HISTORIC AND DESIGN REVIEW COMMISSION

September 18, 2019

HDRC CASE NO: 2019-531
ADDRESS: 1518 E GRAYSON ST
LEGAL DESCRIPTION: NCB 1258 BLK LOT A3
ZONING: C-2 IDZ, H
CITY COUNCIL DIST.: 2
DISTRICT: Government Hill Historic District
APPLICANT: Timothy Cone
OWNER: Tim Sanford/1518 GRAYSON LLC
TYPE OF WORK: Exterior modifications, Historic Tax Certification
APPLICATION RECEIVED: September 06, 2019
60-DAY REVIEW: November 04, 2019
CASE MANAGER: Edward Hall

The applicant is requesting a Certificate of Appropriateness for approval to:

① WALL SECTION @ GRAYSON STOREFRONT
1/4" = 1'-0"

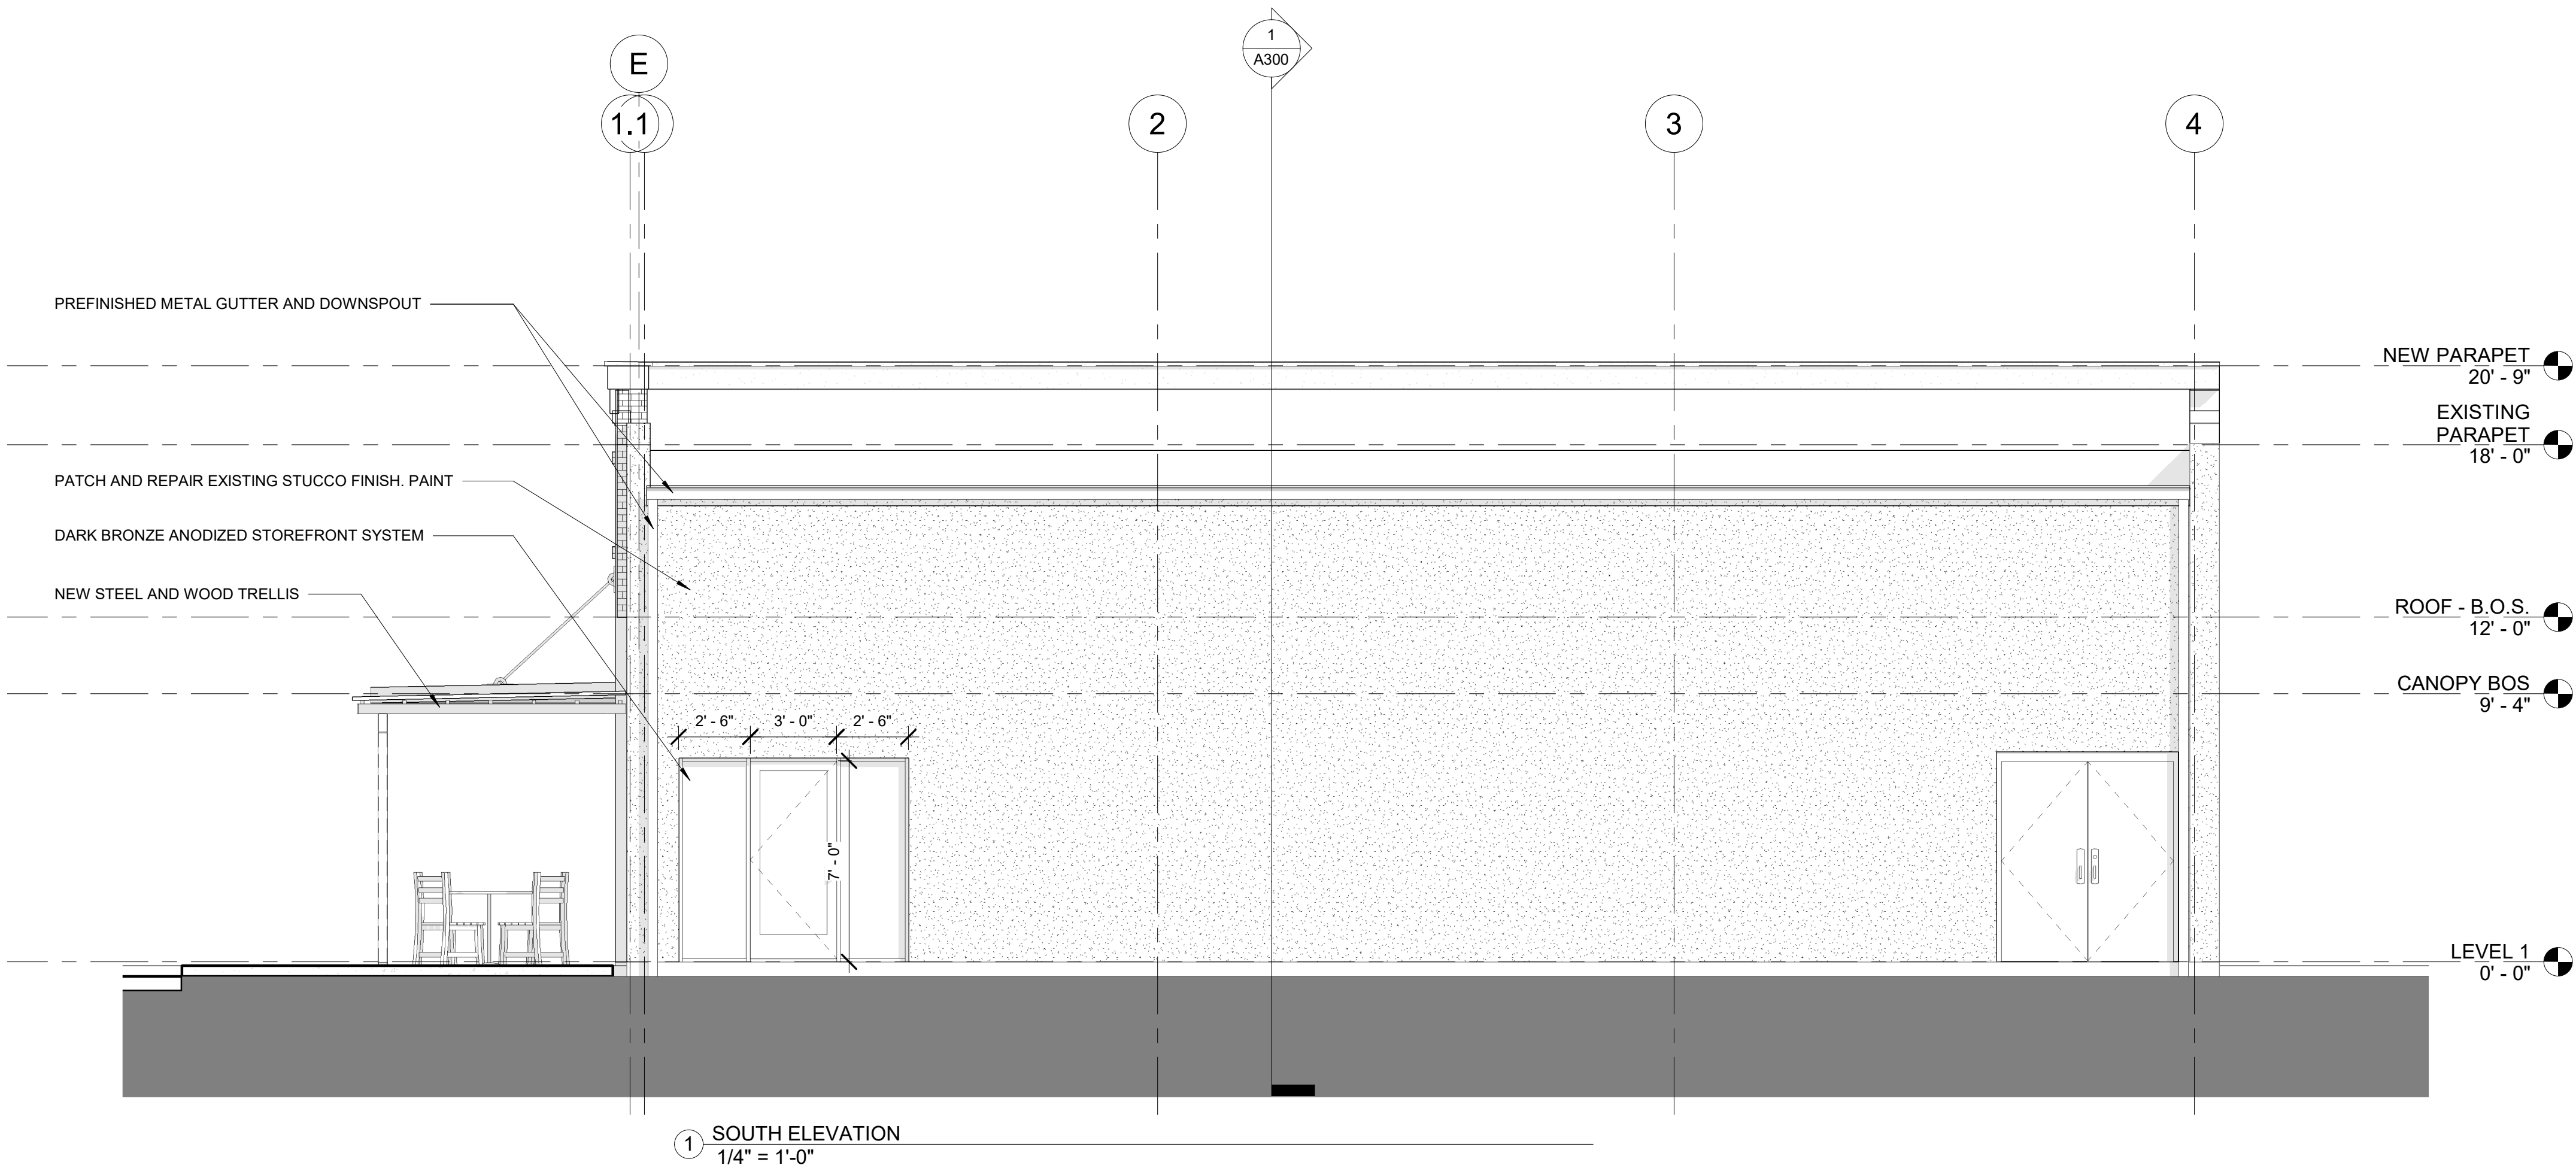
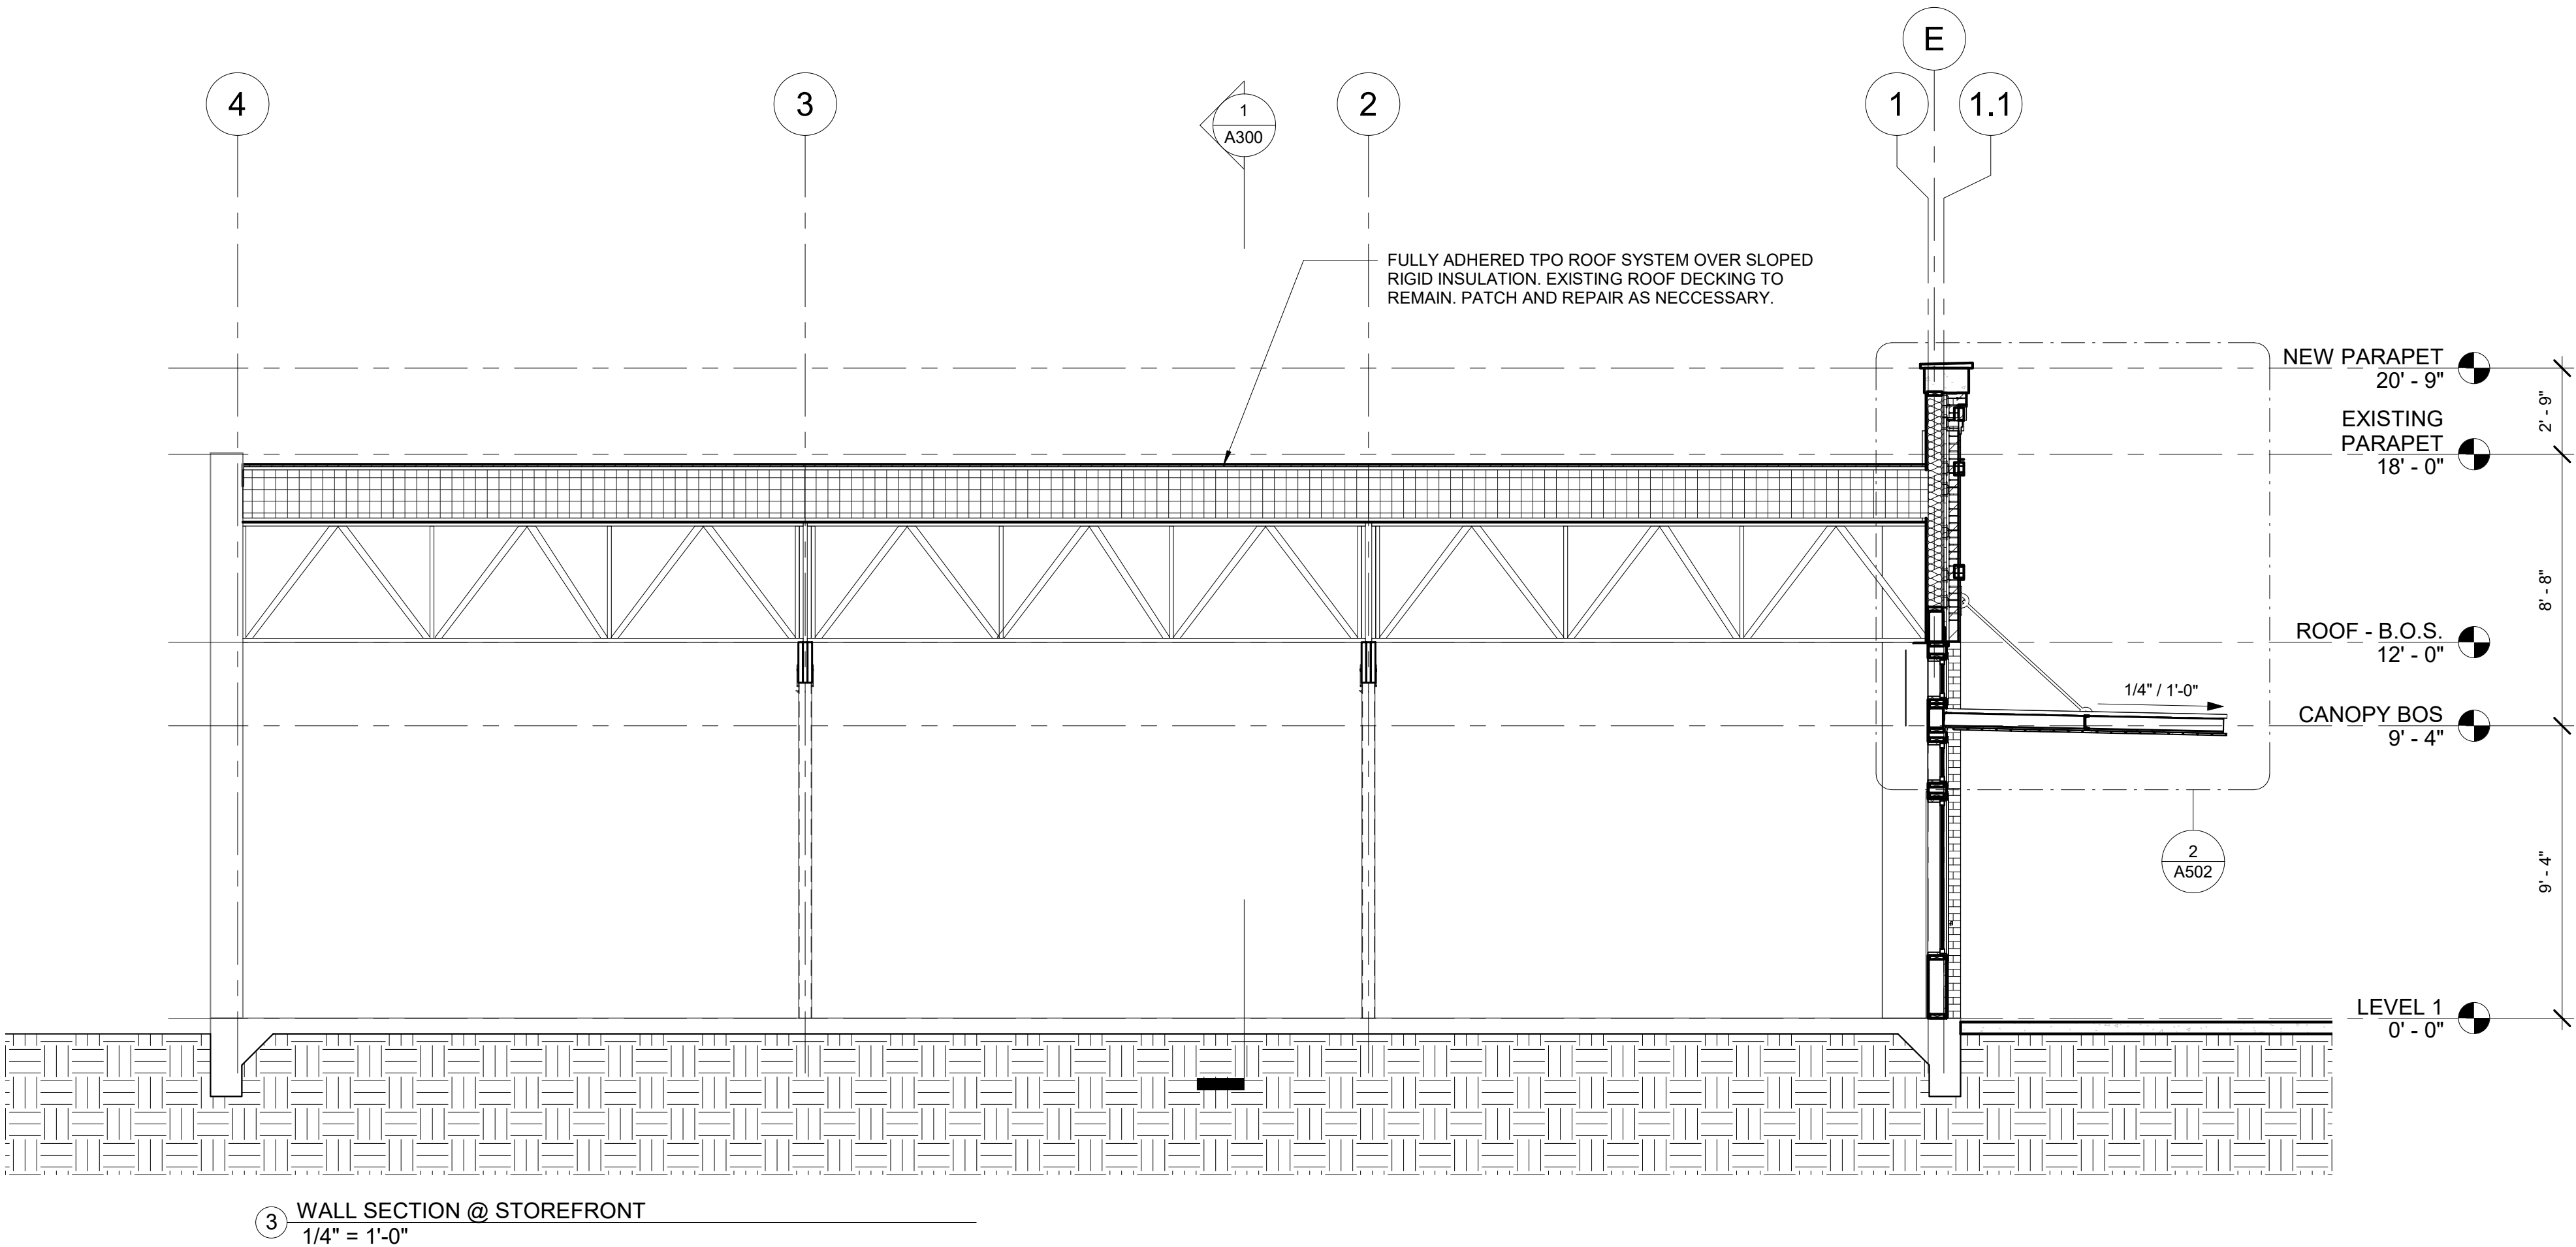
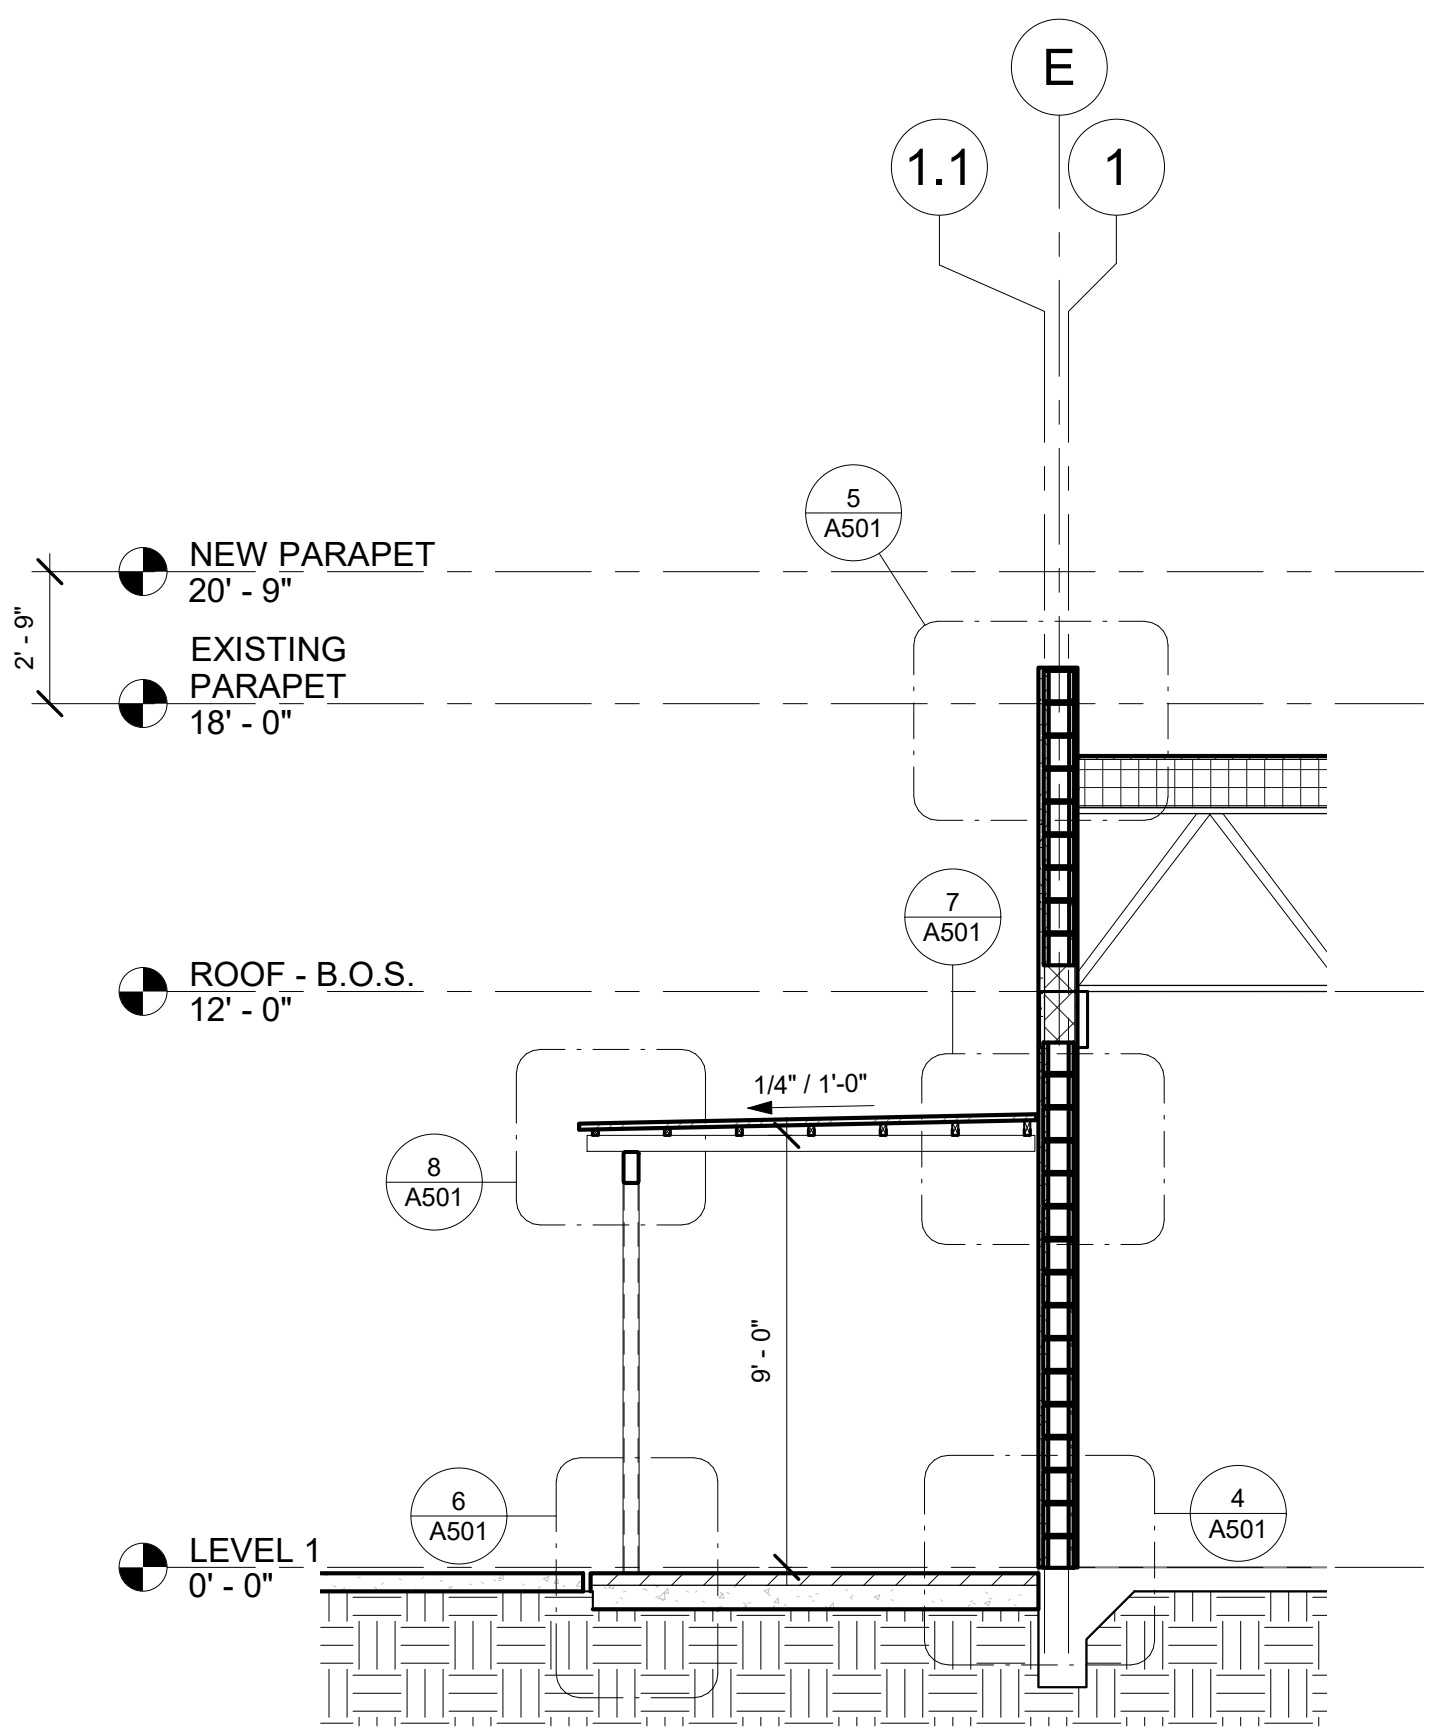
- c. **STOREFRONT SYSTEM** – The applicant has proposed to replace the existing, non-original storefront system. The applicant has proposed a glazed aluminum storefront system to feature pony walls and transom lights that are located and scaled appropriately; however, staff finds that the storefront system beneath the transom should not feature multiple vertical storefront panels. Staff finds that the proposed storefront system should feature dark mullions and frames.

- i. That the proposed storefront system feature dark frames and mullions, and that only one vertical storefront panel should be installed beneath the canopy, rather than one large and one small panel beneath the canopy as proposed.
